U.S. NUCLEAR REGULATORY COMMISSION
In the Matter of U.S. Army (Jefferson Proving Ground)
Docket No. 40-8838-MLA Official Exhibit No. 1.
OFFERED by: Applicant/Licensee (Intervenor) Save The Valley
NRC Staff Other
IDENTIFIED on Witness/Panel
Action Taken: ADMITTED REJECTED WITHDRAWN
Reporter/Clerk

PREFILED DIRECT TESTIMONY AND EXHIBITS OF

IN SUPPORT OF CONTENTION B-1

OF INTERVENOR SAVE THE VALLEY, INC.

Figure 1. Reversible Exchange with Stream

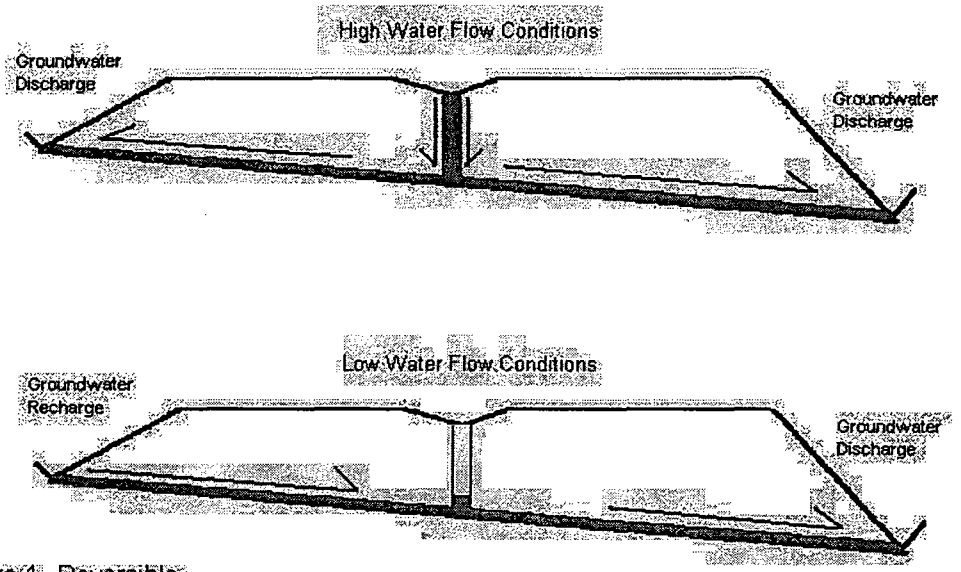
The deficiency in the surface water gauging and staging tasks is that the premise of the current conceptual model is that there *is* karst flow underlying the JPG DU site. The objective of the characterization is the same, *i.e.*, provide the fate and transport modeling with an accurate description of how much groundwater flow is carrying how much DU how quickly from the impact area to the locations of potential exposure. But, groundwater no longer is conceptualized as simply moving toward and into the local

streams, driven by in-basin topography. A karst network may discharge groundwater to the local stream. But, a karst network may recharge with water taken from the local stream, transport it through the karst system of the bedrock and discharge it back to the stream downstream of the surface water monitoring network. A karst network may also recharge with water taken from a local stream and discharge it to a stream in an entirely different basin. Karst groundwater and DU in or transported by that groundwater is undetectable by a gauging and staging system designed for non-karst hydrogeology when the karst system which actually exists discharges outside the confines of the surface water monitoring system.

This deficiency is further complicated because the interaction of a karst network and surface water drainage can and often does change temporally. Figure 1 shows a schematic of a simple karst network and how it can change with respect to its impacts on streams that it intersects. During high recharge conditions, groundwater in the karst network is recharged from precipitation and discharges to both streams. However, during low water flow conditions, the karst system recharges from precipitation and from the stream with the higher elevation and discharges only to the lower steam. Stream-flow separation of gauging data on either stream will produce an erroneous interpretation of the aquifer recharge unless the location and the transient nature of the karst interaction are known. The gauging and staging tasks proposed in the FSP and related addenda cannot account for even such a simple transient interaction and cannot, therefore, provide the data to the fate and transport model that is needed.

A.037 The stream/cave gauging and stream staging activities in the modified FSP are not designed to document and quantify groundwater and surface-water interactions. Such a design is fundamentally needed to generate the data that are meaningful to the fate and transport modeling required to support site decommissioning. Achieving a design capable of supporting a decision on site decommissioning will require work not presently in the modified FSP.

Figure 2. Caves under DU Impact Area

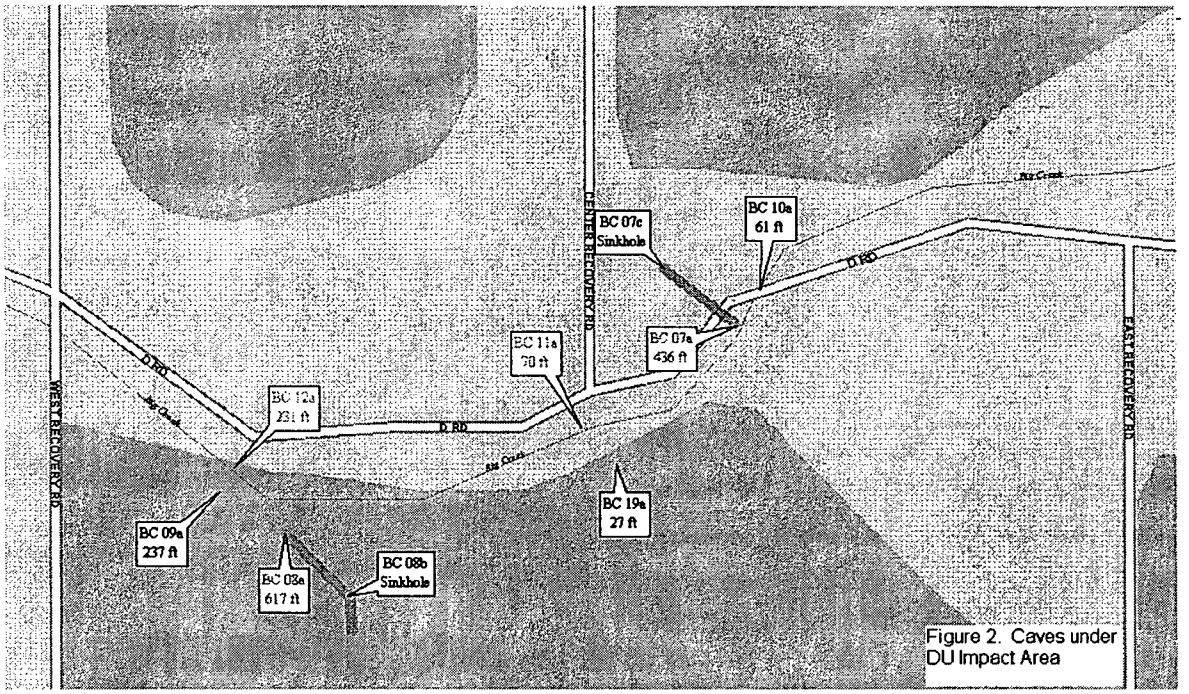
- The cave survey that was performed at JPG in the mid- to late 1990s is not fully and appropriately incorporated into the location and selection process. Almost two miles of caves were entered, surveyed and mapped during the JPG Karst Study (Sheldon, 1997). The karst study entered and mapped 19 caves in the Big Creek drainage basin. Among these caves the study surveyed 34 separate entrances and 3085 feet of caves large enough from human entry. Some of the mapped caves extend under the heart of the DU impact area. Along the reach of Big Creek within the DU impact area, the karst study entered and mapped 7 caves with an aggregate mapped length of 1679 feet and 13 separate entrances. The two longest accessible caves mapped in the Big Creek drainage basin are under the DU impact area, BC-07 with 436 feet and BC-08 with 617 feet. Each of these caves moves from Big Creek back toward heavily contaminated portions in the DU impact area as represented in Figure 2-5 on page 2-11 of the FSP. Each also has an entrance in a sink hole in the vicinity of the heavily contaminated areas. Figure 2 depicts the approximate locations of the mapped caves under the DU impact area.

- Failure to verify the FTA/EI approach with the patterns and existence of known conduits and sink holes is an additional deficiency. Comparing the cave traces on Figure 2 with the fracture traces from the FTA (Figure 3-1, page 3-2 of Addendum 3) shows that the longest mapped cave under the DU impact area, BC-08, is not coincident with a fracture trace. Clearly the FTA doesn't identify all, if any, of major shallow groundwater conduits. The second longest mapped cave, BC-07, may
